Village of Dobbs Ferry New York

Gould Park Improvements 2023

ADDENDUM NO. 3 September 8, 2023

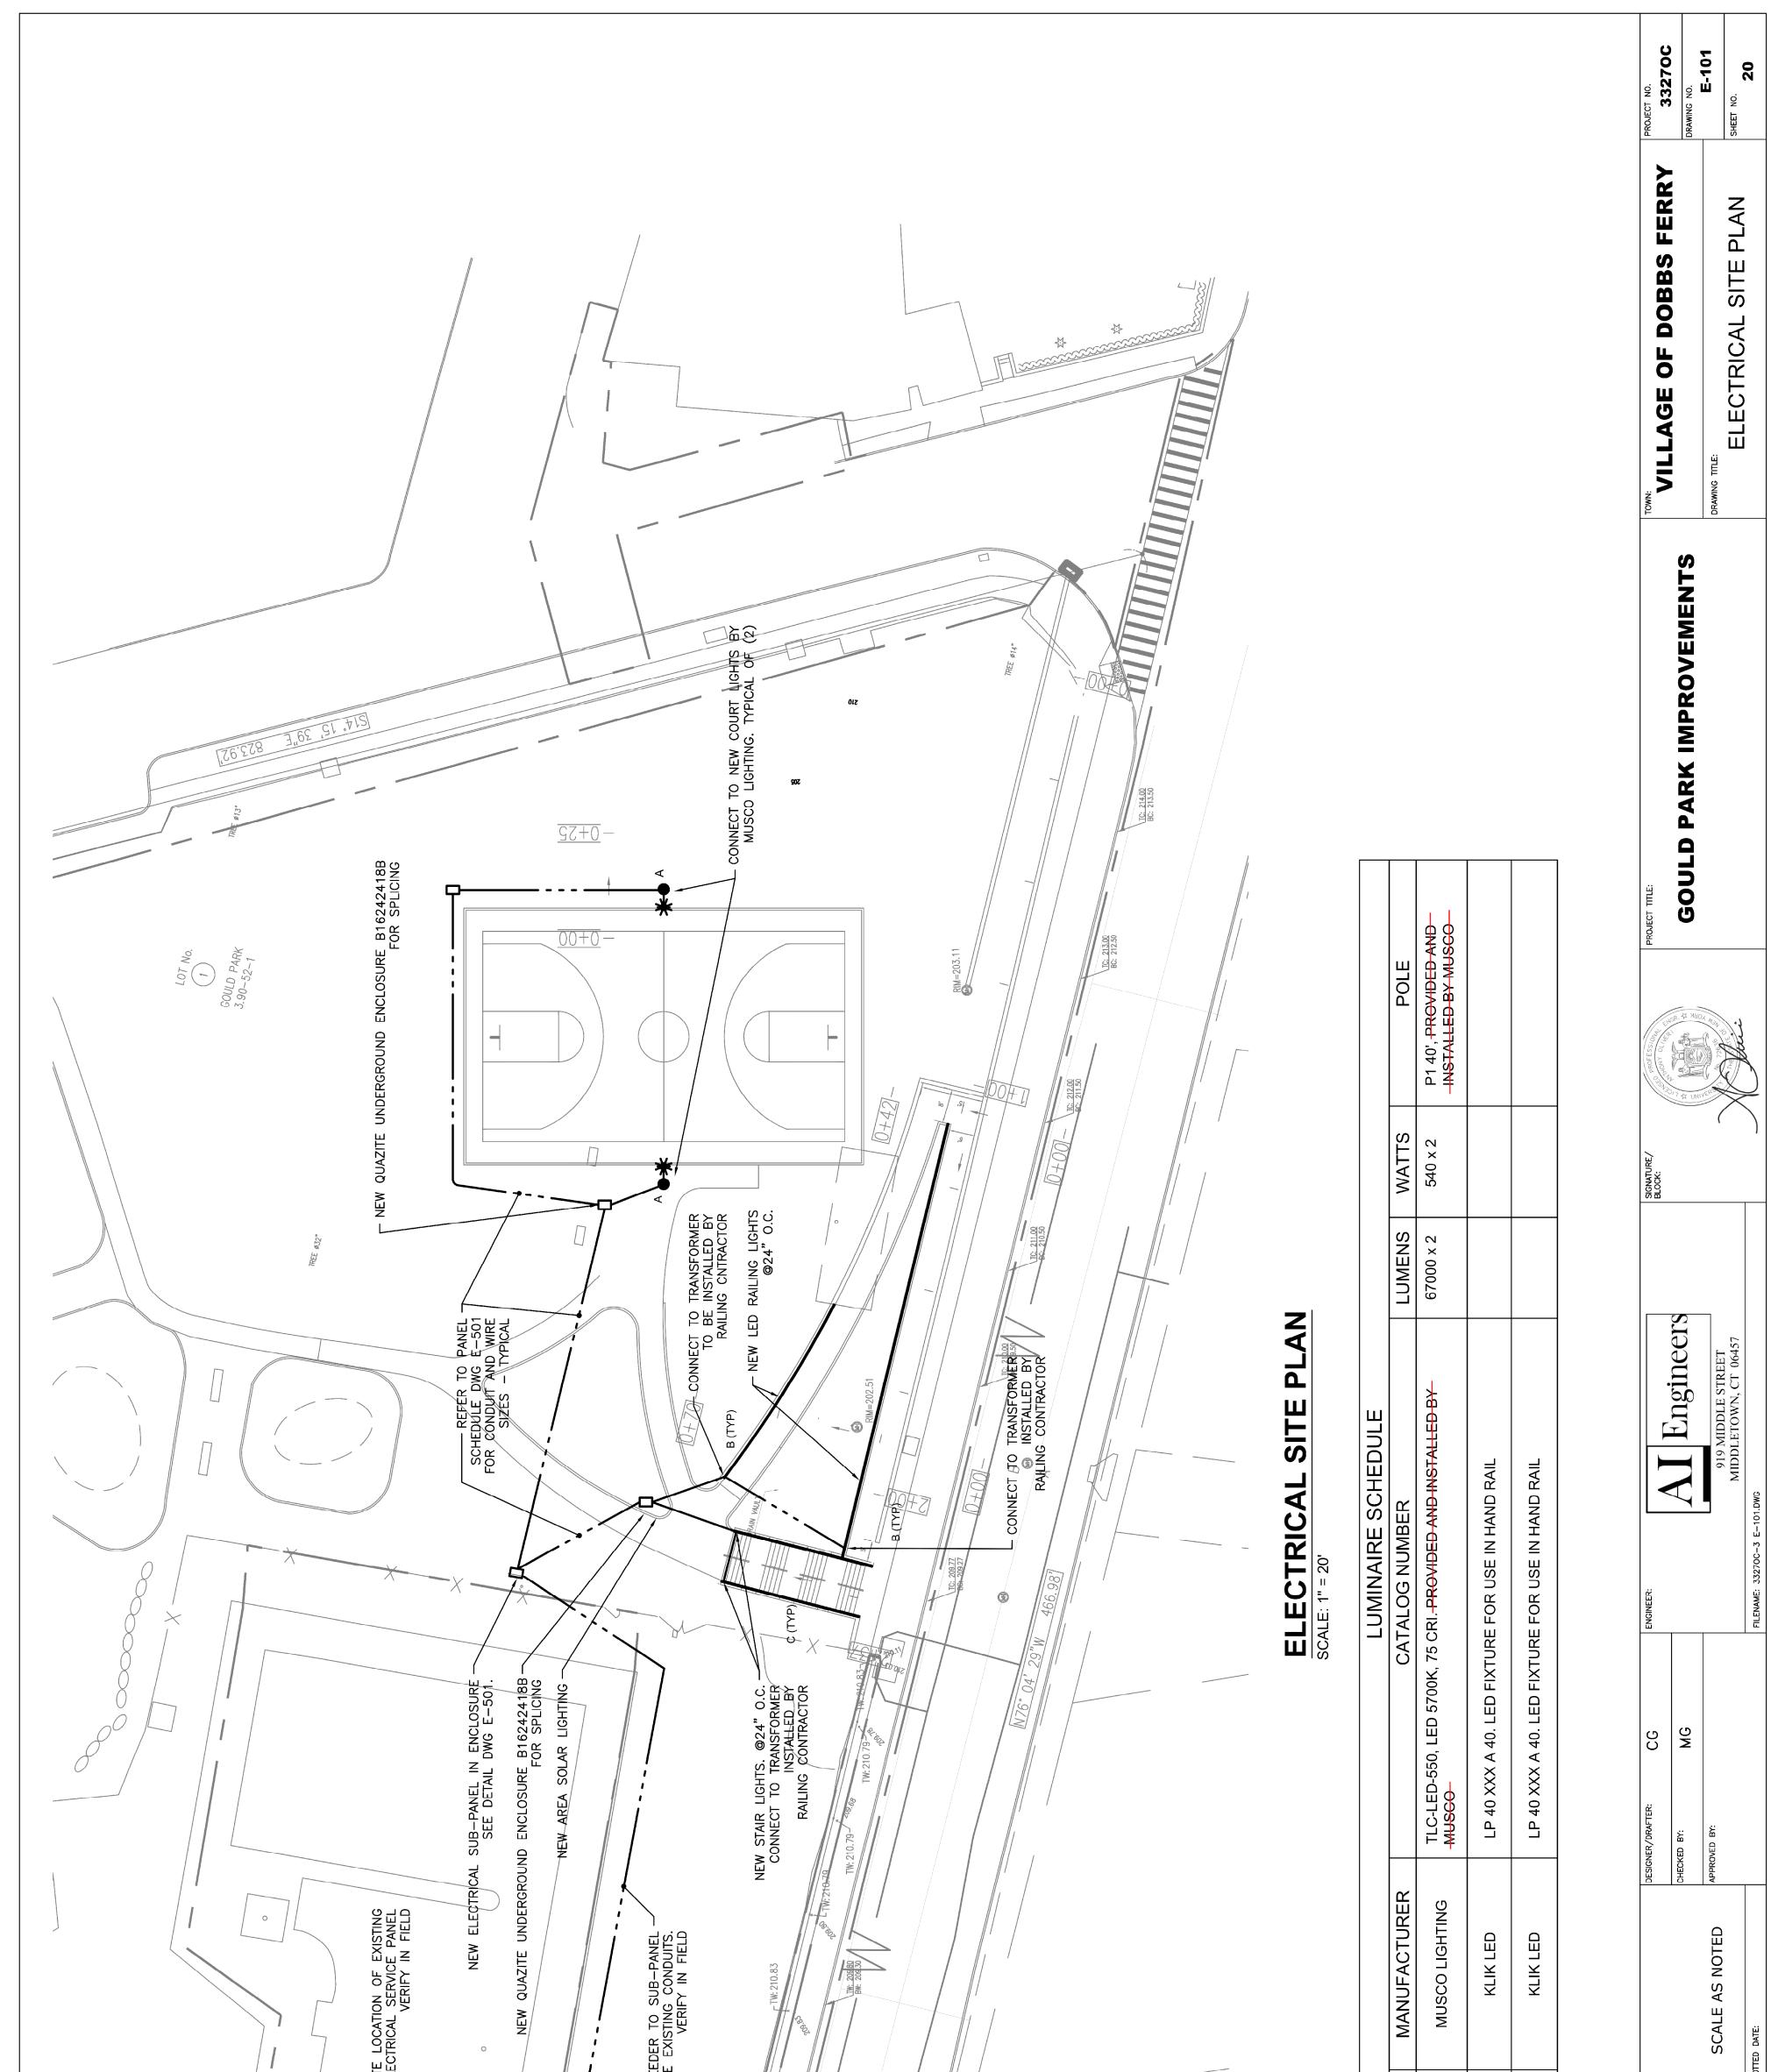
1) See attached Sheet E-101: Electrical Site Plan, the Luminaire schedule previously stated, "Provided and installed by Musco." However, the lighting fixtures, poles and related equipment shall be provided and installed by the contractor.
